From: Comar, Manny
Sent: Thursday, November 01, 2012 5:05 PM
To: TurkeyCOL Resource
Subject: FW: DRAFT RAI Responses FPL Turkey Point 6 & 7 for eRAI 6006 Basic Geologic and Seismic Information
Attachments: Draft Revised Response for NRC RAI Letter No. 040, RAI 02.05.04-4 (eRAI 6006).pdf; Draft Revised Response for NRC RAI Letter No. 040, RAI 02.05.04-13 (eRAI 6006).pdf; Draft Revised Response for NRC RAI Letter No. 040, RAI 02.05.04-22 (eRAI 6006).pdf

NRC RAI Letter No. PTN-RAI-LTR-040

SRP Section: 02.05.04 - Stability of Subsurface Materials and Foundations

NRC RAI Number: 02.05.04-13 (eRAI 6006)

Figure 1: 5% Damping ARS at Ground Surface – Near NI, Envelope of LF and HF

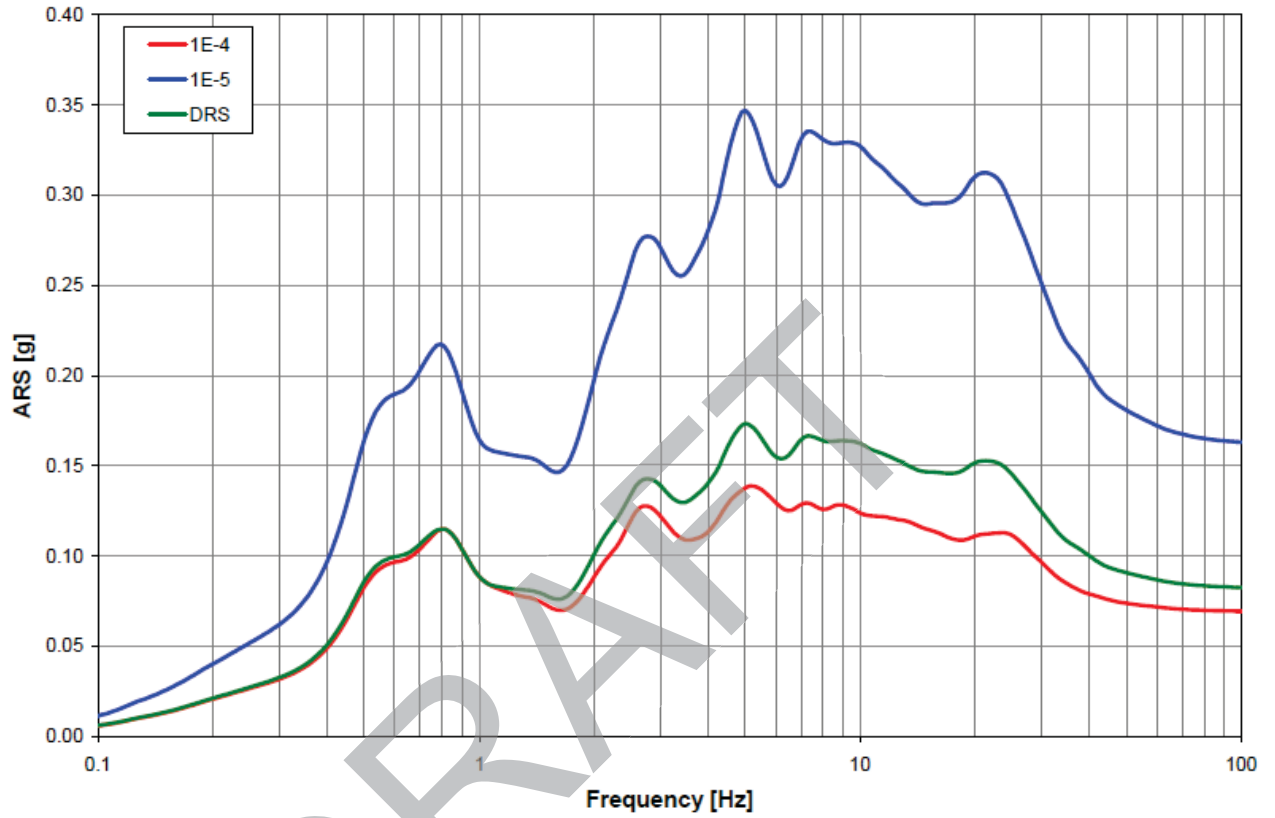
The lateral earth pressure diagram shown in Figure 2.5.4-240 shows a plot corresponding to the dynamic lateral earth pressure. The shape of this plot appears to be consistent with the shape for dynamic pressure considering a rigid structural wall (see ASCE 4). In Section 2.5.4.10.4.2 "Seismic Lateral Earth Pressures", the active seismic pressure was computed using the Mononobe-Okabe equation. The last sentence of the section indicates that at-rest pressure as a function of depth for below-grade walls is developed consistent with Reference 277 (ASCE-4) using the design ground motion. It is noted that the pressure developed using the ASCE-4 methodology uses the z_{pa} value from the input motion.

Figure 2.5.2-252 shows the input motion (GMRS) developed for the site, the GMRS is located at Elevation -35. In this Figure the z_{pa} is approximately 0.058g. However, the elevation of the GMRS is considerably lower than the surface of the soils adjacent to the basement walls that are to be evaluated for seismic lateral earth pressure. In accordance with NUREG-0800, Standard Review Plan, Chapter 2.5.4, "Stability of Subsurface Materials and Foundations," please clarify on the definition of the design ground motion, and how that motion is consistent with Appendix S to 10CFR50.

FSAR Figure 2.5.2-253 and FSAR Table 2.5.2-228 show the zero period acceleration (z_{pa}) for the GMRS as about 0.058g. This z_{pa} value was not considered appropriate when computing lateral earth pressure because it was developed for El. -35 feet. The Design Response Spectra (DRS) at 5% damping, calculated at the ground surface for the near Nuclear Island (NI) and far from NI soil sites, were considered appropriate for computing lateral earth pressure, using the envelope of low frequency (LF) and high frequency (HF) acceleration response spectra (ARS) at 10^{-4} and 10^{-5} annual probability of exceedance. These ARS envelopes and the DRS are plotted in Figures 1 and 2 for the near NI and far from NI soil sites, respectively. From Figures 1 and 2, the peak ground acceleration at the ground surface is equal to approximately 0.0824g and 0.0806g (DRS at 100 Hz) for the near NI and far from NI soil sites, respectively.

Regarding the computation of active seismic pressure using the Mononobe-Okabe equation, according to Whitman (Reference 1), use of horizontal ground acceleration for design at the base level of the wall may result in underestimating the movements; Reference 1 states that it seems best to use the acceleration at the surface of the backfill, or an average between the surface and the base of the wall. Thus, an acceleration of 0.1g, rather than the peak ground acceleration of 0.0824g (near NI) or 0.0806g (far from NI), is conservatively used in the Mononobe-Okabe equation.

Similarly, for the computation of at-rest seismic pressure using the ASCE 4-98 method, an acceleration of 0.1g, rather than the peak ground acceleration of 0.0824g (near NI) or 0.0806g (far from NI), is conservatively used.
